dsPIC30F1010/202X Family Silicon Errata and Data Sheet Clarification

The dsPIC30F1010/202X family devices that you have received conform functionally to the current Device Data Sheet (DS70178C), except for the anomalies described in this document.

FIGURE 1:

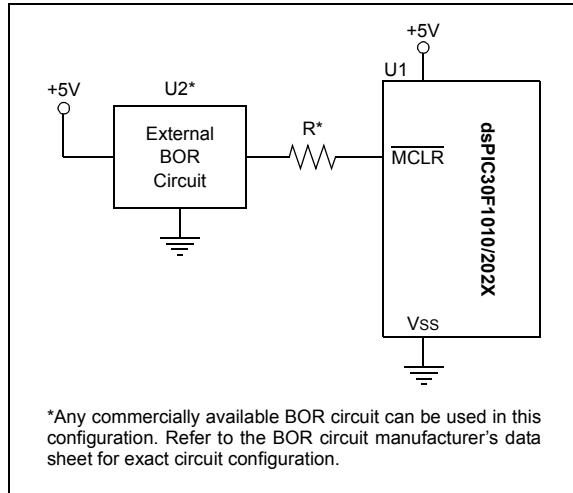
A brown-out event occurs when VDD drops below the minimum operating voltage for the device, but not all the way down to VSS. When the dsPIC DSC SMPS device is running with the PLL enabled, and a brown-out event occurs, the device may stop running and the MCLR pin will not reset the device. If this occurs, the device can only be reset by cycling power to the VDD pins.

It is recommended that an external Brown-out Reset (BOR) circuit be used to hold the device in Reset, during a brown-out event, to overcome this problem. The external BOR circuit will use the MCLR pin to hold the device in Reset. The following work around, in combination with the external BOR circuit, will ensure that the device is cleanly reset after a brown-out event occurs.

The dsPIC DSC SMPS device must be powered up with the PLL disabled, the Fail-Safe Clock Monitor (FSCM) enabled and clock switching enabled. The PLL should be enabled in software via a clock switch after the device is reset (refer to **Section 29. "Oscillator"** (DS70268) in the "dsPIC30F Family Reference Manual" for details on clock switching). This ensures that the MCLR pin is functional and that the device can be reset by an external BOR circuit (see [Figure 1](#)).
